**CONCEPT EVALUATIONS
And
COMMENTS RECEIVED**

**LINWOOD/EASTERN AVENUE
INTERCHANGE FOCUS AREA**

Eastern Corridor Segments II and III

Continuous Right Turn Lane From SR 125 to Wooster

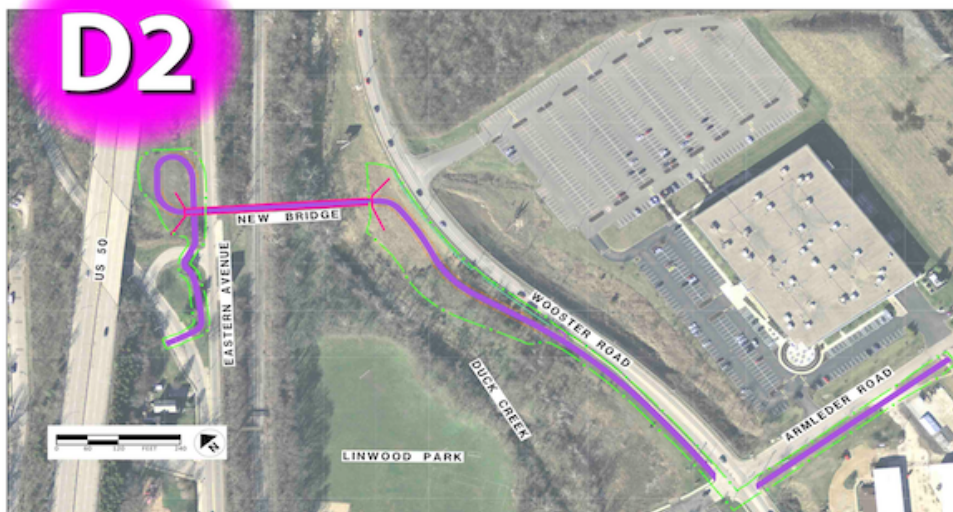
NO.	COMMENT	RESPONSE
1	Option D1 is terrible - continuous right turns promote increased speed, and will only minimally improve travel times at the cost of vastly decreased pedestrian and cyclist safety.	Thank you for your comments. Your input is appreciated and will be taken into consideration as we evaluate the options and develop our recommendations.
2	Regarding D1 - not needed; the traffic is manageable as is.	Thank you for your comments. Your input is appreciated and will be taken into consideration as we evaluate the options and develop our recommendations.

Shared-Use Path from Eastern to Armleder Park

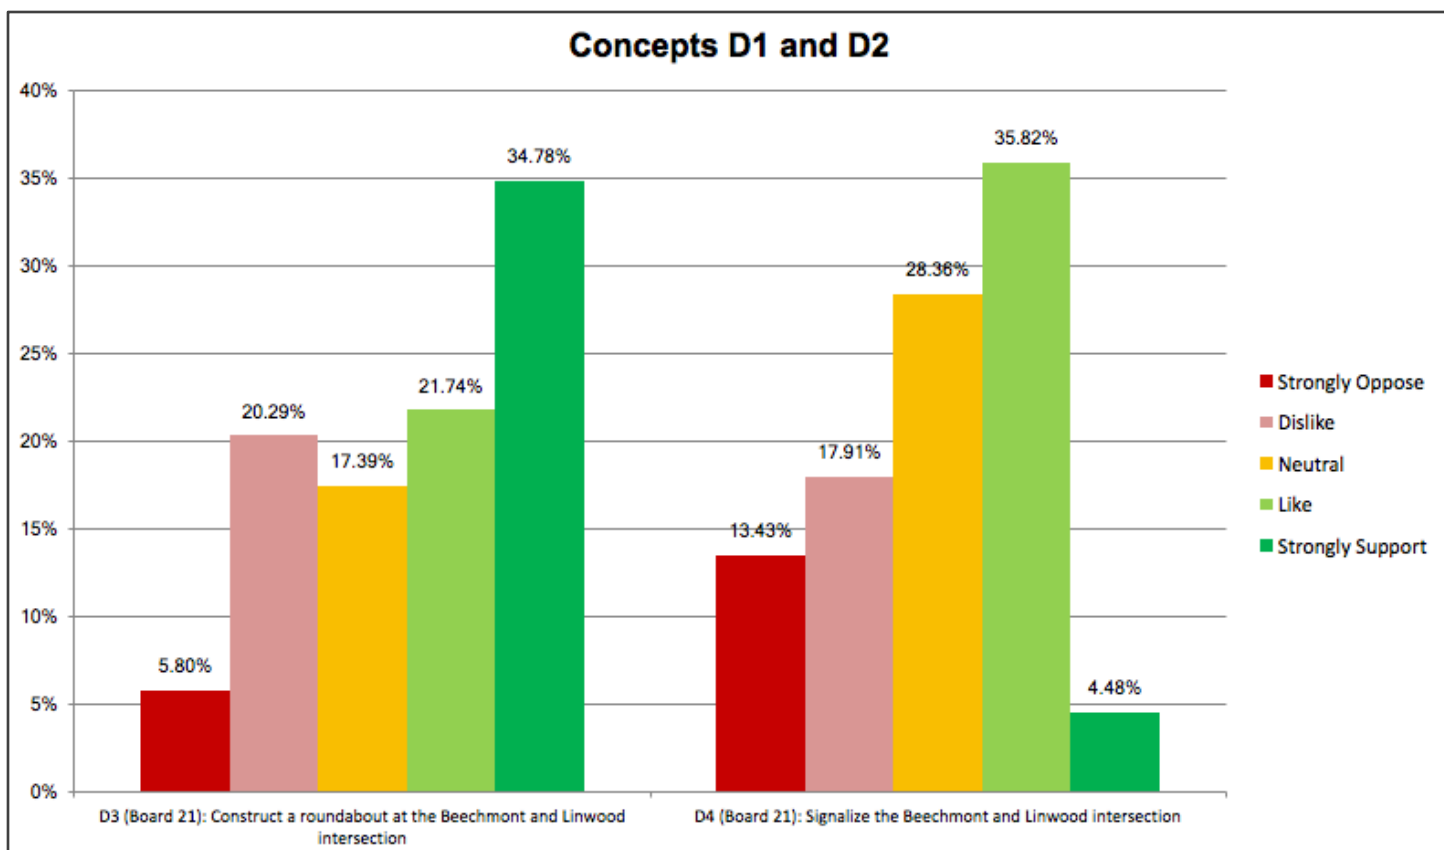
NO.	COMMENT	RESPONSE
1	D2 - amount of usage?	Thank you for your comments. This concept would be an additional connection that would link to concept E5 which connects Wasson to Armleder and could also connect the eastern avenue community to Armleder Park. However, a projection of the number of anticipated users has not yet been developed.
2	I think that there needs to be a focus on providing a safe way for bicycles to travel on Wooster Road and D2 comes way too far down the road to actually accomplish that. It is nice that it provides a cut across to Eastern Ave, but I'm not sure what that would help since it doesn't start until way down the road by the US Bank facility.	<p>Thank you for your comments. Your input is appreciated and will be taken into consideration as we evaluate the options and develop our recommendations.</p> <p>Based on public comment and Advisory Committee discussions, it has been noted that Concept D2 by itself does not adequately meet the needs due to its location in relation to where the potential users are. Therefore, this concept will be considered as a connection in conjunction with Concept E5, which brings Wasson Way to Armleder along US 50.</p>

3	On D2 Board 20, it's essential to get riders from Eastern to Armleder so we don't have bikers on Columbia Parkway - that's dangerous to them and to cars.	Thank you for your comments. Your input is appreciated and will be taken into consideration as we evaluate the options and develop our recommendations.
4	Regarding D2 - please see comments about shared-use paths on page 3 <i>[Respondent shared a general comment about all of the shared-use path options: while I am not opposed to adding these at some point, there is a much greater need to alleviate the vehicle traffic and those issues need to be addressed first].</i>	Thank you for your comments. Your input is appreciated and will be taken into consideration as we evaluate the options and develop our recommendations.

Roundabout at Beechmont and Linwood Intersection

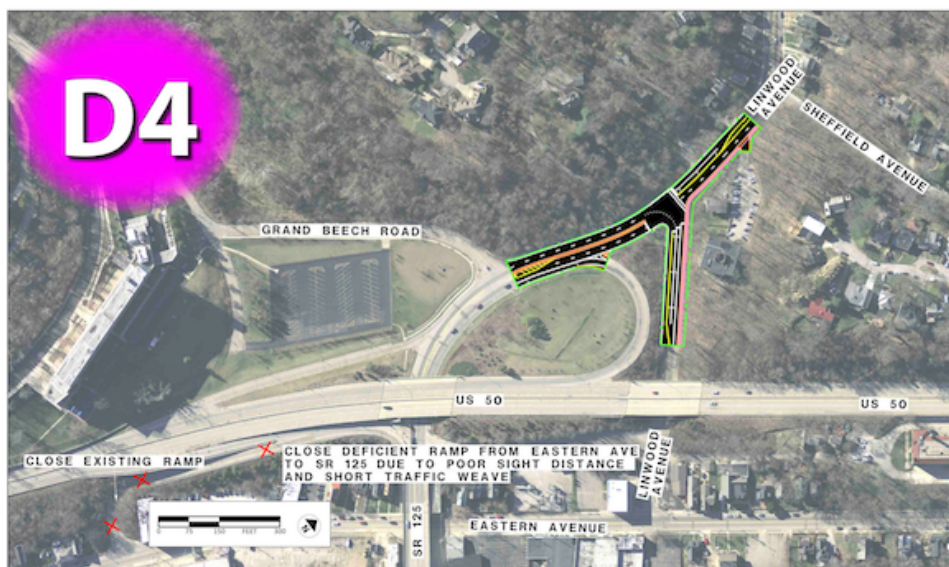
NO.	COMMENT	RESPONSE
1	D3 - Would be chaotic.	Thank you for your comment. Your input is appreciated and will be taken into consideration as we evaluate the options and develop our recommendations.
2	D3 - Close road south of 50 connection to Linwood!!	Thank you for your comment. Your input is appreciated and will be taken into consideration as we evaluate the options and develop our recommendations.

NO.	COMMENT	RESPONSE
3	D3, D4 - Too expensive for improvement gain	Thank you for your comment. Your input is appreciated and will be taken into consideration as we evaluate the options and develop our recommendations.
4	I like the D3 roundabout option and agree with what it will achieve, but it seems like disappointed [sic] that the cost is so much more than the signalized interchange option.	Thank you for your comments. Your input is appreciated and will be taken into consideration as we evaluate the options and develop our recommendations.
5	D3 - To me, installing a roundabout would create bigger problems and slow traffic even more.	Thank you for your comments. Your input is appreciated and will be taken into consideration as we evaluate the options and develop our recommendations.
6	Like D5 & D3 combination.	Thank you for your comment. Your input is appreciated and will be taken into consideration as we evaluate the options and develop our recommendations.

Signalized Intersection at Beechmont and Linwood

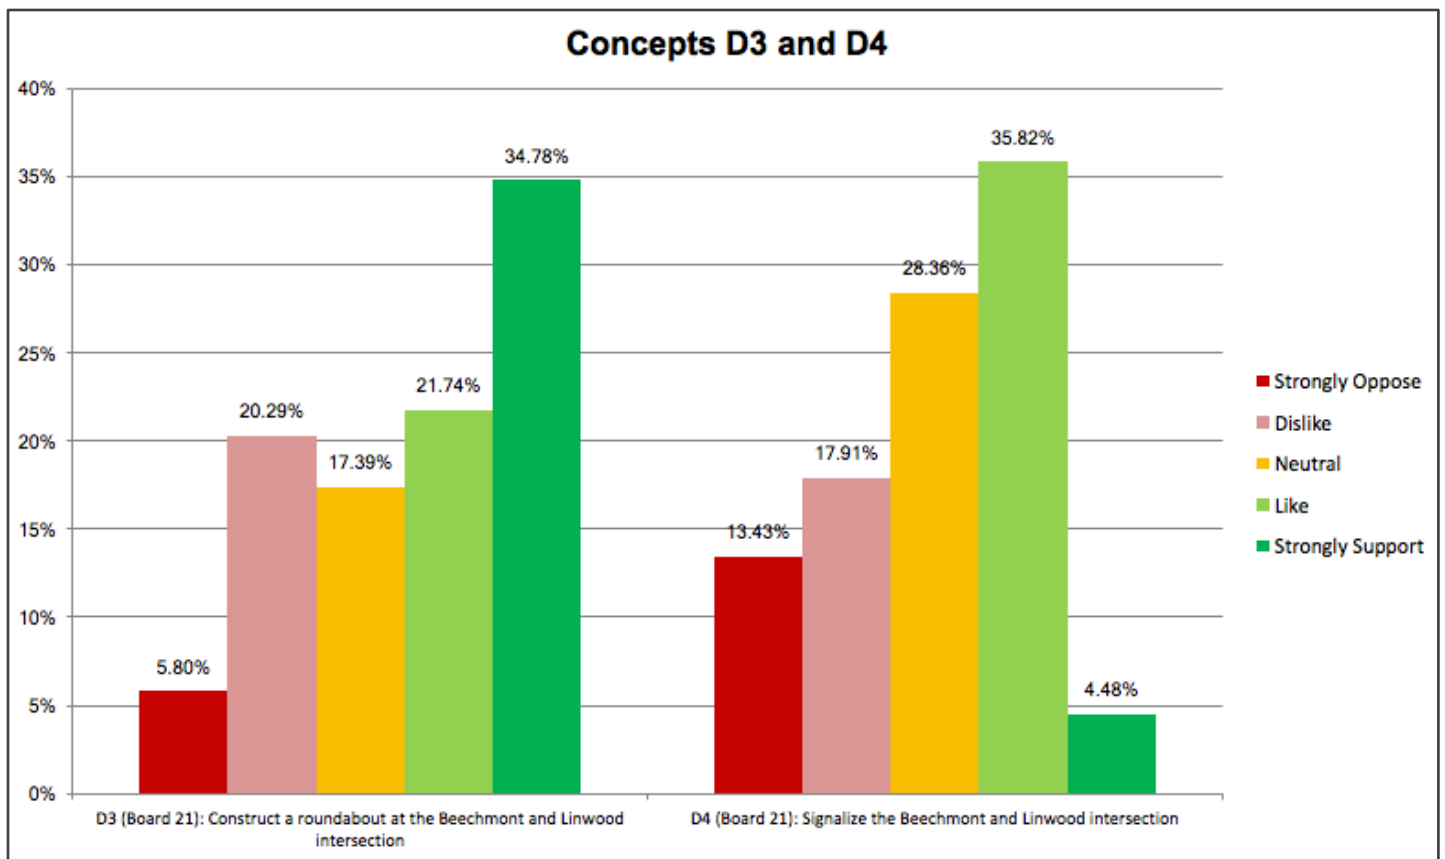
NO.	COMMENT	RESPONSE
1	D4 is the better option but still not ideal.	Thank you for your comment. Your input is appreciated and will be taken into consideration as we evaluate the options and develop our recommendations.
2	D4 - If it's not as long as turning left on Eastern from Linwood. Very long red now!	Thank you for your comment. Your input is appreciated and will be taken into consideration as we evaluate the options and develop our recommendations.
3	D3, D4 - Too expensive for improvement gain	Thank you for your comment. Your input is appreciated and will be taken into consideration as we evaluate the options and develop our recommendations.

NO.	COMMENT	RESPONSE
1	D3 - yes close the ramp!	Thank you for your comment. After reviewing public comment and further Advisory Committee discussions, it was determined that there will be no recommendation to move forward with closing the ramp at this time. The intersection improvements shown in D3 and D4 could be advanced in the future without closing the ramp, if desired.
2	<p><i>Received via email:</i></p> <p>I had a question as to why the proposal to close the Eastern Avenue on Ramp to Beechmont Avenue has been put forth? I have no opinion either way as of yet, but as someone who frequently uses it would like to know why this has been proposed. Thank you!</p>	<p><i>Response sent via email:</i></p> <p>I wanted to let you know that we received your email. I'm forwarding it on to one of our team members who will be able to provide you with more detail and will get back with you soon on a response!</p> <p>Talk more with you then, Laura Whitman Eastern Corridor Communications Team</p> <p><i>Follow-up Response sent:</i></p> <p>I've heard back from the project team and wanted to share the following with you . . . Like you, a number of people have asked why closing the ramp that connects Eastern to Beechmont has been suggested. The reason is that the existing design of the ramp presents a challenge for drivers - drivers going up the ramp from Eastern cannot see vehicles coming down the ramp from Columbia Parkway (and vice versa). Also, there is very little space available for vehicles from both Eastern and Columbia Parkway to merge together while on the ramp. These challenges present safety concerns for all involved. That said, planners recognize that this ramp is currently the most direct access from Eastern to Beechmont. Therefore, the ramp would be closed only if an alternate access route is put in place. Several such alternatives have been developed and are now out for public review. Illustrations of these concepts are shown with the Oct. 24 & 25 Open House meeting materials on the Segments II and III Public Involvement page - see concepts D3, D4 and D6 on Boards 21 and 22.)</p> <p>At this point, these alternatives - including the proposed ramp closure - are concepts only and have not yet been approved, nor has any construction money been identified. Public review of these concepts is an important part of the project development process and your feedback is critical as planners determine how or even if these concepts should be advanced for further development.</p>

4	<p><i>Received via email:</i></p> <p>With such limited access points to and from Eastern Avenue, it concerns me that the closure of this ramp would increase traffic and travel times for people wanting travel on the Beechmont Levee. Will alternative configurations be considered for access to the levee from points between Airport Road and the on Ramp to 50 if this is closed? Also this is likely to load additional traffic onto Wooster Road and 50 in Fairfax which is extremely problematic at this time anyway. What are</p>	<p><i>Response sent via email:</i></p> <p>Thank you for your comments - we appreciate you taking the time to send them in and will make sure to share them with the project planners.</p> <p>A number of people have asked why closing the ramp that connects Eastern to Beechmont has been suggested. The reason is that the existing design of the ramp presents a challenge for drivers - drivers going up the ramp from Eastern cannot see vehicles coming down the ramp from Columbia Parkway (and vice versa). Also, there is very little space available for vehicles from both Eastern and Columbia Parkway to merge together while on the</p>

5	Do not close Eastern Ave on-ramp to Beechmont. Traffic counts and accident data don't support closing and improvements aren't dependent	<p>Thank you for your comments. A number of people have asked why closing the ramp that connects Eastern to Beechmont has been suggested. The reason is that the existing design of the ramp presents a challenge for drivers - drivers going up the ramp from Eastern cannot see vehicles coming down the ramp from Columbia Parkway (and vice versa). Also, there is very little space available for vehicles from both Eastern and Columbia Parkway to merge together while on the ramp. These challenges present safety concerns for all involved. That said, planners recognize that this ramp is currently the most direct access from Eastern to Beechmont. Therefore, the ramp would be closed only if an alternate access route is put in place. Public review is an important part of the project development process and your feedback is critical as planners determine how or even if these concepts should be advanced for further development. Your input is appreciated and will be</p>

NO.	COMMENT	RESPONSE
7	As the Linwood/East end begins to revitalize, this access ramp is going to be imperative to allow residents of Newtown, Anderson, etc. easy access to and from the area.	<p>Thank you for your comment. A number of people have asked why closing the ramp that connects Eastern to Beechmont has been suggested. The reason is that the existing design of the ramp presents a challenge for drivers - drivers going up the ramp from Eastern cannot see vehicles coming down the ramp from Columbia Parkway (and vice versa). Also, there is very little space available for vehicles from both Eastern and Columbia Parkway to merge together while on the ramp. These challenges present safety concerns for all involved. That said, planners recognize that this ramp is currently the most direct access from Eastern to Beechmont. Therefore, the ramp would be closed only if an alternate access route is put in place. Public review is an important part of the project development process and your feedback is critical as planners determine how or even if these concepts should be advanced for further development. Your input is appreciated and will be taken into consideration as we evaluate the options and develop our recommendations.</p> <p>After reviewing public comment and further Advisory Committee discussions, it was determined that there will be no recommendation to move forward with closing the ramp at this time. The intersection improvements shown in D3 and D4 could be advanced in the future without closing the ramp, if desired.</p>

8	Please do not close this ramp we travel this three times a week to pick my sister up for church. We travel down from West Chester exit Red Bank get off on Eastern Ave. go on this ramp up Beechmont to her apt in Mt. Washington 3x a week.... please do not do this we've been area residents of Eastern Ave. most of our lives and consider this a valuable access ramp to Beechmont Levee.	<p>Thank you for your comments. A number of people have asked why closing the ramp that connects Eastern to Beechmont has been suggested. The reason is that the existing design of the ramp presents a challenge for drivers - drivers going up the ramp from Eastern cannot see vehicles coming down the ramp from Columbia Parkway (and vice versa). Also, there is very little space available for vehicles from both Eastern and Columbia Parkway to merge together while on the ramp. These challenges present safety concerns for all involved. That said, planners recognize that this ramp is currently the most direct access from Eastern to Beechmont. Therefore, the ramp would be closed only if an alternate access route is put in place. Public review is an important part of the project development process and your feedback is critical as planners determine how or even if these concepts should be advanced for further development. Your input is appreciated and will be taken into consideration as we evaluate the options and develop our recommendations.</p> <p>After reviewing public comment and further Advisory Committee discussions, it was determined that there will be no recommendation to move forward with closing the ramp at this time. The intersection improvements</p>

NO.	COMMENT	RESPONSE
9	<p>I live on Eastern Ave and use this on ramp multiple times a week to get to Beechmont. It would be a mistake to close this. The other way I would have to go to get on Beechmont is turn left at the bottom of Linwood Ave hill. This is a very dangerous place to turn left on and at times is almost impossible with the heavy traffic flow coming down Linwood and coming from Beechmont. I was recently almost involved in a car accident there from someone Pulling out in front of me making a left turn as I was trying to turn right to go to Eastern. There are already quite a few wrecks there and closing the on ramp from eastern would not be a wise choice. Not only do a lot of cars use it but school buses as well. Please for safety reasons leave it open!</p>	<p>shown in D3 and D4 could be advanced in the future without closing the ramp, if desired.</p> <p>Thank you for your comments. A number of people have asked why closing the ramp that connects Eastern to Beechmont has been suggested. The reason is that the existing design of the ramp presents a challenge for drivers - drivers going up the ramp from Eastern cannot see vehicles coming down the ramp from Columbia Parkway (and vice versa). Also, there is very little space available for vehicles from both Eastern and Columbia Parkway to merge together while on the ramp. These challenges present safety concerns for all involved. That said, planners recognize that this ramp is currently the most direct access from Eastern to Beechmont. Therefore, the ramp would be closed only if an alternate access route is put in place. Public review is an important part of the project development process and your feedback is critical as planners determine how or even if these concepts should be advanced for further development. Your input is appreciated and will be taken into consideration as we evaluate the options and develop our recommendations.</p> <p>After reviewing public comment and further Advisory Committee discussions, it was determined that there will be no recommendation to move forward with closing the ramp at this time. The intersection improvements shown in D3 and D4 could be advanced in the future without closing the ramp, if desired.</p>

10	<p>Please keep the Eastern Avenue on ramp to the Beechmont Levee as it is used regularly by us. Thank you.</p>	<p>Thank you for your comments. A number of people have asked why closing the ramp that connects Eastern to Beechmont has been suggested. The reason is that the existing design of the ramp presents a challenge for drivers - drivers going up the ramp from Eastern cannot see vehicles coming down the ramp from Columbia Parkway (and vice versa). Also, there is very little space available for vehicles from both Eastern and Columbia Parkway to merge together while on the ramp. These challenges present safety concerns for all involved. That said, planners recognize that this ramp is currently the most direct access from Eastern to Beechmont. Therefore, the ramp would be closed only if an alternate access route is put in place. Public review is an important part of the project development process and your feedback is critical as planners determine how or even if these concepts should be advanced for further development. Your input is appreciated and will be taken into consideration as we evaluate the options and develop our recommendations.</p> <p>After reviewing public comment and further Advisory Committee discussions, it was determined that there will</p>

NO.	COMMENT	RESPONSE
	the alternatives for access to/from Eastern Avenue in this area.	<p>ramp. These challenges present safety concerns for all involved. That said, planners do recognize that this ramp is currently the most direct access from Eastern to Beechmont. Therefore, the ramp would be closed only if an alternate access route is put in place. To your question, several such alternatives have been developed and are now out for public review. Illustrations of these concepts are shown with the Oct. 24 & 25 Open House meeting materials on the Segments II and III Public Involvement page - see concepts D3, D4 and D6 on Boards 21 and 22.)</p> <p>At this point, these alternatives - including the ramp closure - are concepts only and have not yet been approved, nor has any construction money been identified. Public review of these concepts is an important part of the project development process and your feedback is critical as planners determine how or even if these concepts should be advanced for further development.</p> <p>I hope this information is helpful. Please let me know if you have further questions.</p> <p>Sincerely, Laura Whitman Eastern Corridor Communications Team</p> <p><i>Additional ODOT response:</i> After reviewing public comment and further Advisory Committee discussions, it was determined that there will be no recommendation to move forward with closing the ramp at this time. The intersection improvements shown in D3 and D4 could be advanced in the future without closing the ramp, if desired.</p>

NO.	COMMENT	RESPONSE
		<p>taken into consideration as we evaluate the options and develop our recommendations.</p> <p>After reviewing public comment and further Advisory Committee discussions, it was determined that there will be no recommendation to move forward with closing the ramp at this time. The intersection improvements shown in D3 and D4 could be advanced in the future without closing the ramp, if desired.</p>
6	<p><i>Received via email:</i></p> <p>This closure closes off the neighborhood from the rest of downtown Cincinnati. It is a major inconvenience for myself, friends and family. They will not come to Cincinnati as frequently this causing a decline in all tourism dollars across the board.</p> <p><i>Follow up message received:</i></p> <p>I misread the diagram and now understand it is hypothetical at this time until funding is secured. However, if it comes up closing the exit to Columbia parkway would be disastrous.</p> <p>The exit ramp from Eastern Avenue onto Beechwood should remain open to ensure optimum traffic flow. A traffic circle would cause even more back and confusion for travelers.</p>	<p><i>Response sent on 10/29:</i></p> <p>Thank you for sending in your comments. However, I wanted to confirm which ramp you are referencing in your comment. The subject line says Columbia Parkway Exit Closure, however, I'm not sure specifically which you are referring to. Can you please clarify? Then, I will be sure to share your comments with the planning team.</p> <p>Thank you very much,</p> <p>Laura Whitman Easter Corridor Communications Team</p> <p><i>Additional ODOT Response:</i></p> <p>Thank you for your comments. A number of people have asked why closing the ramp that connects Eastern to Beechmont has been suggested. The reason is that the existing design of the ramp presents a challenge for drivers - drivers going up the ramp from Eastern cannot see vehicles coming down the ramp from Columbia Parkway (and vice versa). Also, there is very little space available for vehicles from both Eastern and Columbia Parkway to merge together while on the ramp. These challenges present safety concerns for all involved. That said, planners recognize that this ramp is currently the most direct access from Eastern to Beechmont. Therefore, the ramp would be closed only if an alternate access route is put in place. Public review is an important part of the project development process and your feedback is critical as planners determine how or even if these concepts should be advanced for further development. Your input is appreciated and will be taken into consideration as we evaluate the options and develop our recommendations.</p> <p>After reviewing public comment and further Advisory Committee discussions, it was determined that there will be no recommendation to move forward with closing the ramp at this time. The intersection improvements shown in D3 and D4 could be advanced in the future without closing the ramp, if desired.</p>

NO.	COMMENT	RESPONSE
		<p>be no recommendation to move forward with closing the ramp at this time. The intersection improvements shown in D3 and D4 could be advanced in the future without closing the ramp, if desired.</p>

Grade Separated Interchange Connecting Wilmer and Wooster

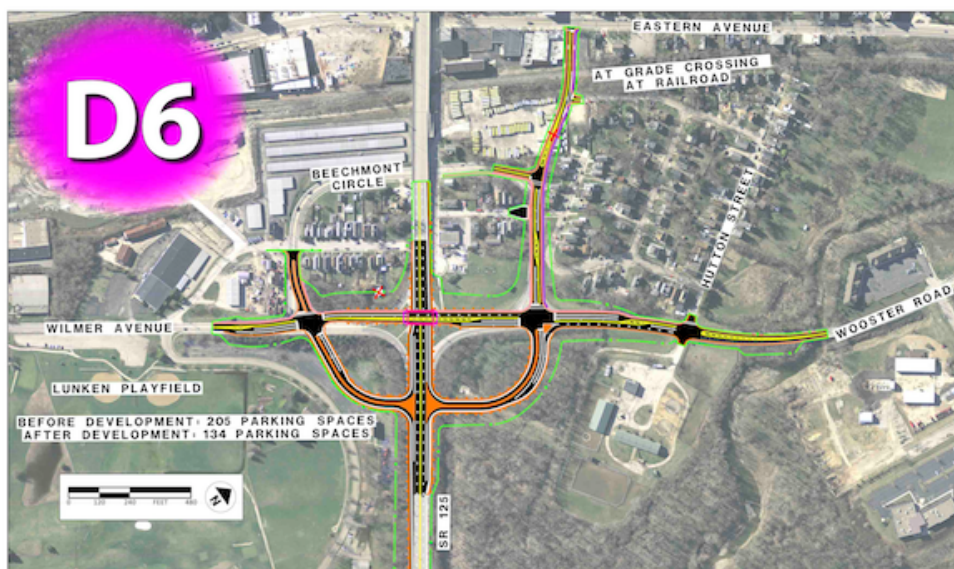
NO.	COMMENT	RESPONSE
1	Like D5 & D3 combination.	Thank you for your comment. Your input is appreciated and will be taken into consideration as we evaluate the options and develop our recommendations.

NO.	COMMENT	RESPONSE
1	D5 and D6 do not address the southbound traffic on Wooster crossing Beechmont and then having to use light to go Eastbound on Beechmont. That is the heaviest traffic pattern. Need to re-engineer this solution. Also, removes recent re-construction of Wooster from Duck Creek to Beechmont Circle. 'doh!	Thank you for your comment. Your input is appreciated and will be taken into consideration as we evaluate the options and develop our recommendations.
